**SUBJECT:** Calvert Cliffs Nuclear Power Plant  
Unit No. 2; Docket No. 50-318  
Core Operating Limits Report for Unit 2, Cycle 14, Revision 3

Please replace the Unit 2 Core Operating Limits Report in its entirety, with the attached Revision 3.

**UNIT 2, CYCLE 14, REVISION 3**

Figure 3.2.3

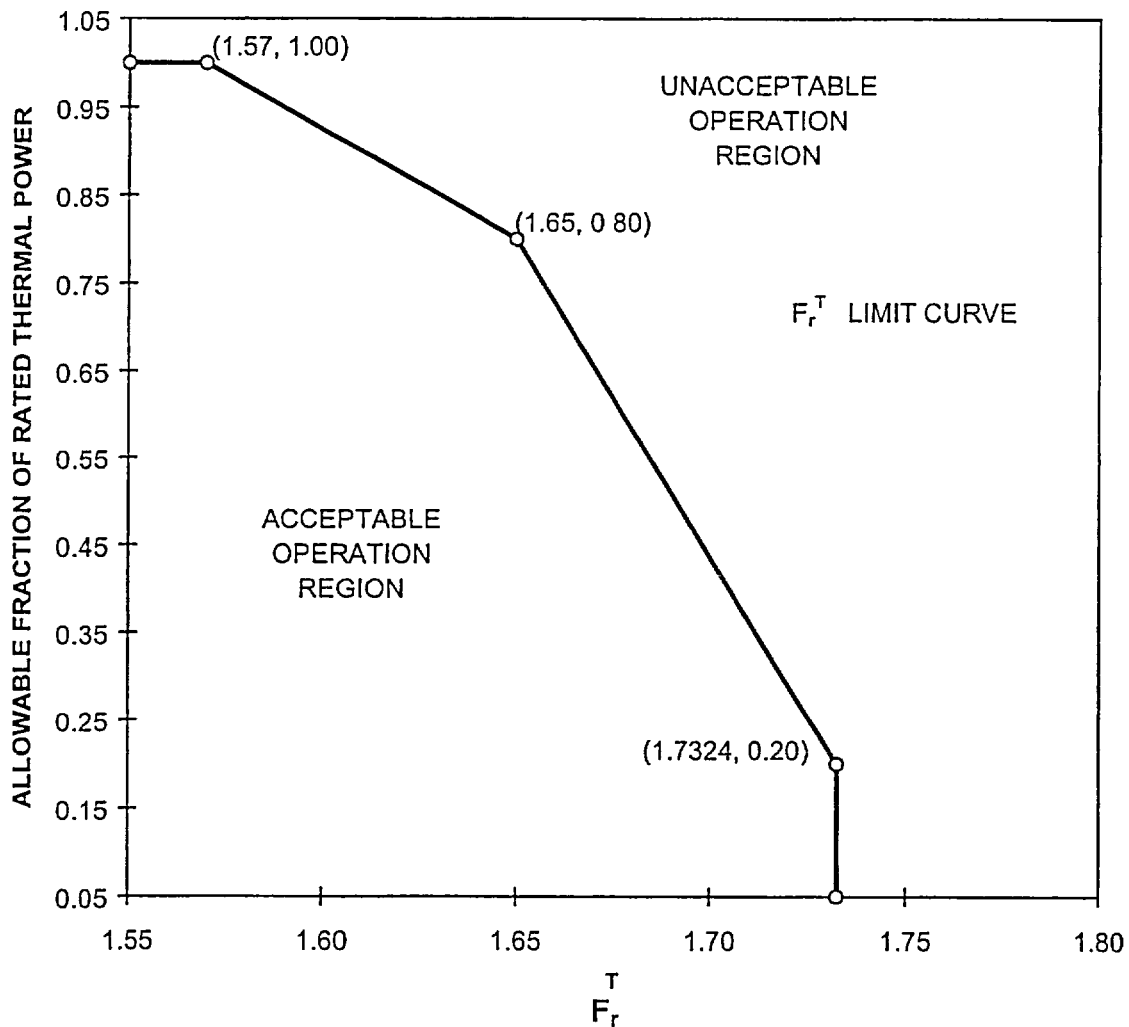
Figure 3.2.3 is revised to implement a more restrictive  $F_r^T$  due to ROPM issues discovered mid-cycle (SE00472, Rev. 0).
